### AMENDMENT TO THE DRAWINGS

U.S. Appl. No. &lt;10/664,294&gt;

### THE INVENTION

**FIG. 9**

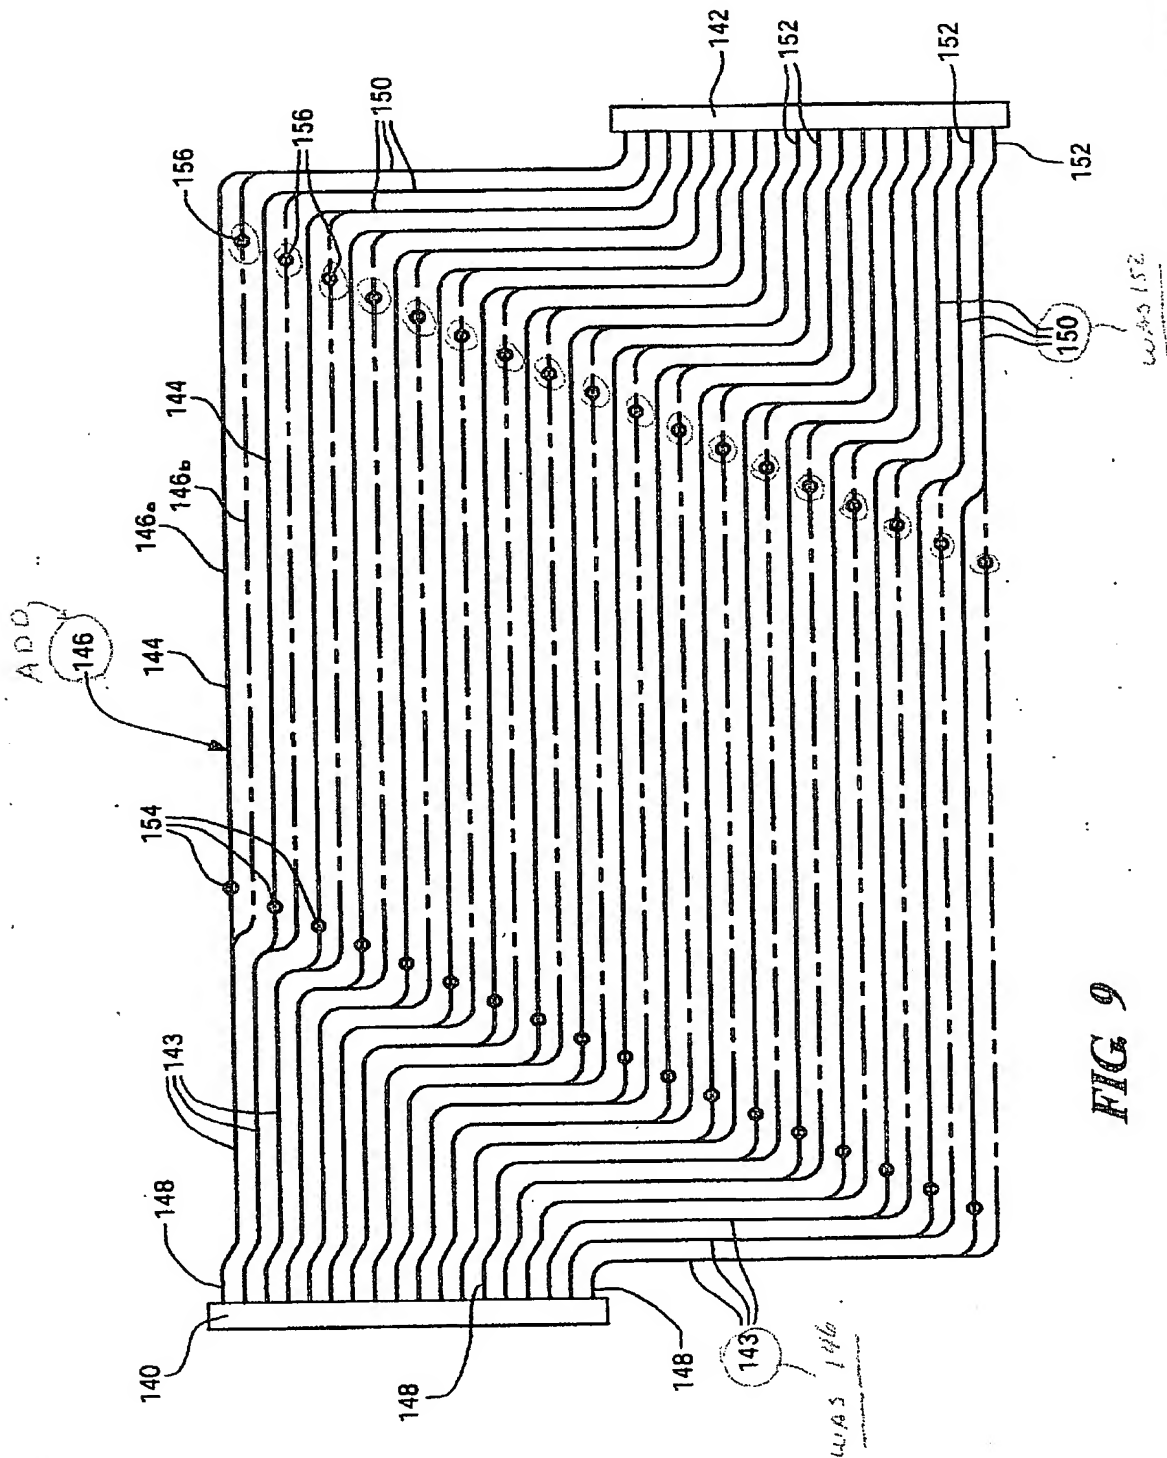
The attached Replacement Sheet of drawings includes changes to Fig. 9 wherein:  
(1) old number 146 has been changed to 143; (2) new number 146 has been added to designate the medial legs of the flow-channels, (3) old number 152 that designated the exit legs has been changed to 150, and (4) flow-restrictors 156 are relocated from flow-channels 146a to flow-channels 146b. An annotated copy of the drawing, showing the changes in red, is also attached.
